**E1466A-01**

**S E R V I C E N O T E**

**E1466A 4x64 Relay Matrix Switch**

**E1466A may fail to open/close relays because of a defective relay driver IC with date code 0325.**

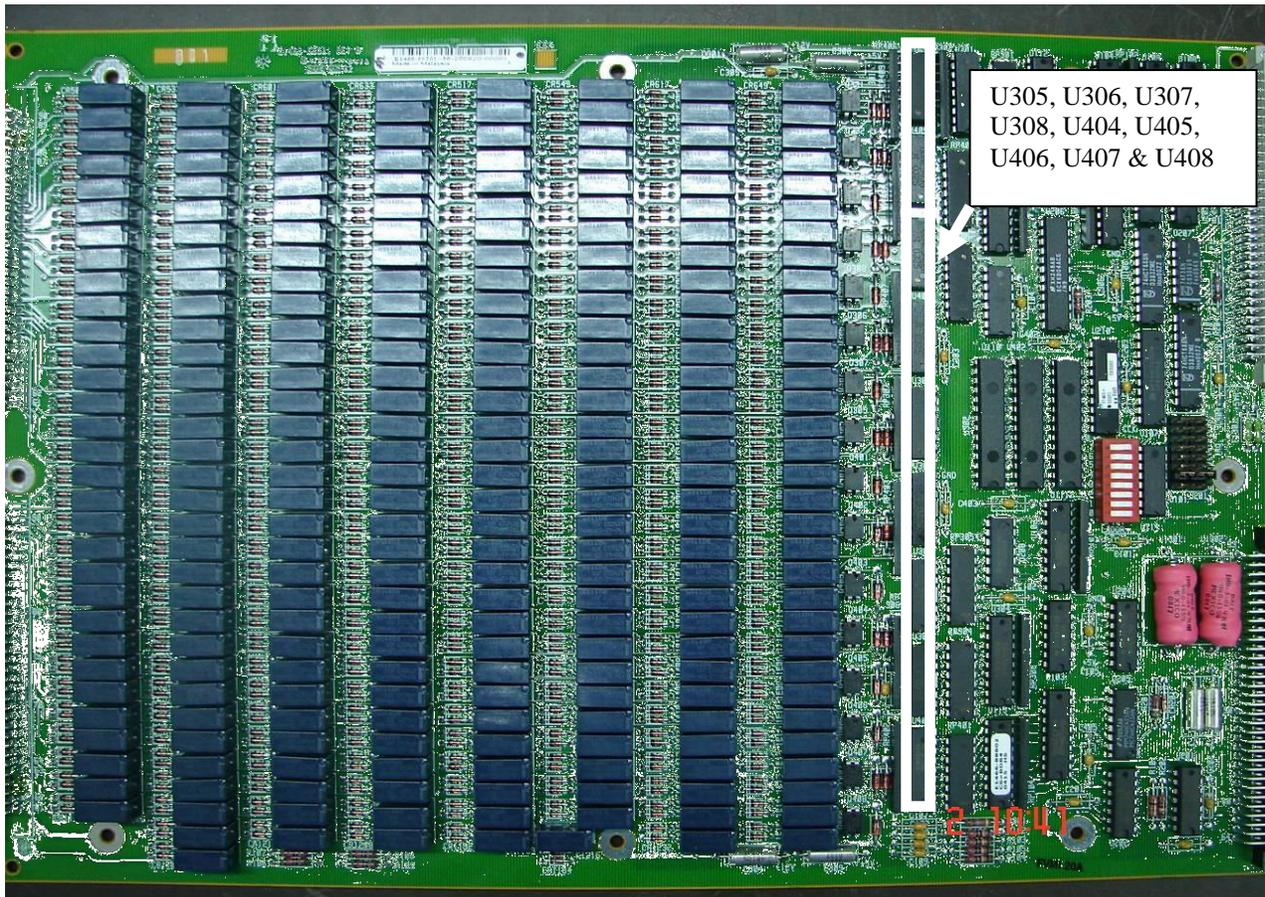
New E1466A shipped between approximately March 2008 and March 2009 may contain a relay driver .chip with a known date code problem.

The relay driver ICs are U305, U306, U307, U308, U404, U405, U406, U407, and U408 which are the LTB part 5188-2550 for 1820-4599.

The bad date code is 0325. This date code has a higher than normal failure rate. Most failures have occurred in the first three months of usage. See the following pictures for part and date code location

A E1466A that fails to close or open it's relays and has the 0325 date code ICs should be replaced with a E1466-66701.
